**INTERLOCAL AGREEMENT BY AND BETWEEN  
THE CITY OF PLANO, TEXAS AND  
NORTH TEXAS MUNICIPAL WATER DISTRICT  
FOR REPAIR OF GABION STRUCTURE – ARBOR HILLS NATURE PRESERVE**

**TO:** NTMWD - Amin Tehrani PhD, PE; Scott Hoelzle PE  
**CC:** City of Plano - Courtney Vanous, MES, REM, CESSWI  
**FROM:** Stephen Norair II, PG; Jonathan Swchwartzenberg, PE, CFM; Keith Byrne, PE, CFM  
**SUBJECT:** Design Recommendation - Arbor Hills Gabion Drop Structure Repair & Improvement  
**DATE:** 12/22/2025  
**PROJECT:** NTD25058/PLA24018

**Table 1.** Rock Riprap Size Gradations used in Gabion Drop Structure Repair and Improvements

# Exhibit 1 - Proposed Repairs & Improvements N.T.S.

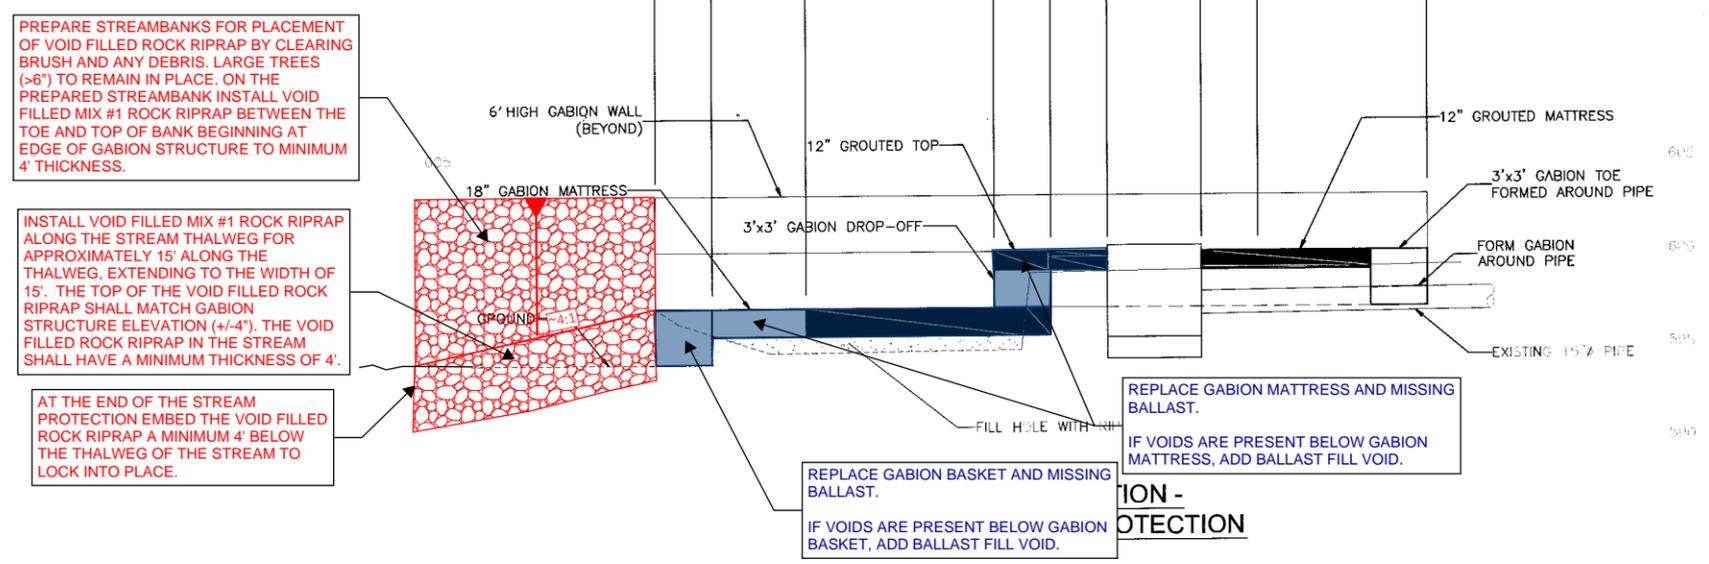
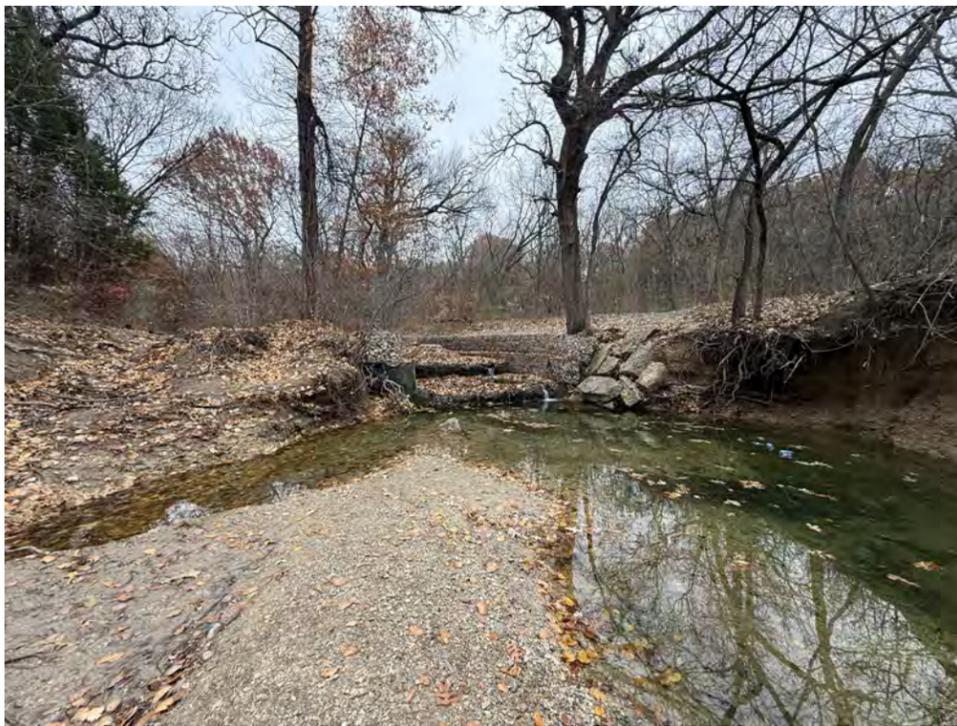
The design approach to repair and improve the gabion drop structure is listed below. These items are also shown on **Exhibits 1**, which overlays the additional rock riprap protection measures over the construction detail from the original gabion drop structure plan set, which overlay the proposed improvements over site photos. The proposed repairs do not address the fundamental stresses that are inherent to this reach of stream. It is suggested that the site be monitored and it should be expected that repairs will be needed in the future.

1. Repair damaged gabion basket and mattress wiring and replace missing ballast as needed. Replace failed gabion mattresses and basket. If a void is present beneath replaced gabion mattresses or basket fill voids with gabion ballast. The location of the gabion structure repairs are shown on **Exhibit 1**.

5. Place Void Filled Mix #1 over the prepared left and right streambank:
    - a. Void Filled Mix #1 should extend from the toe of the streambank and tie into the top of the streambank and wrap around the gabion basket as shown in **Exhibit 1**.

- b. Void Filled Mix #1 should begin at the downstream edge of the gabion structure and continue downstream as shown in **Exhibit 1**.
    - c. The Void Filled Mix #1 should have a minimum thickness of 4 feet.

**Attachment 1 - Observed Site Conditions**

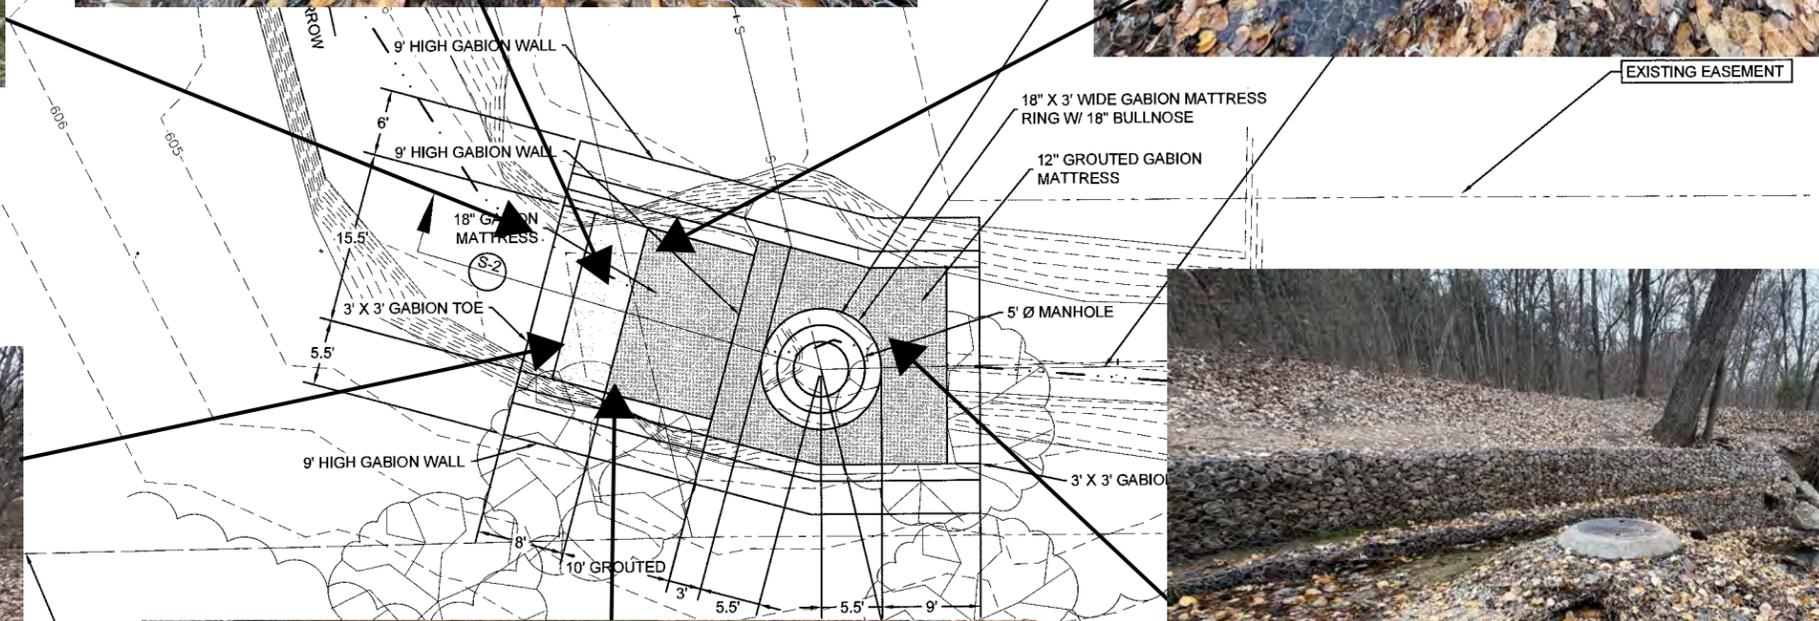
Damaged/failed gabion mattresses and gabions.

Damaged gabion mattresses and gabions. Scour on downstream left bank.

Scour on downstream edges of structure. Failed gabion mattress

Failed gabion mattress

Damaged gabion mattresses and gabions
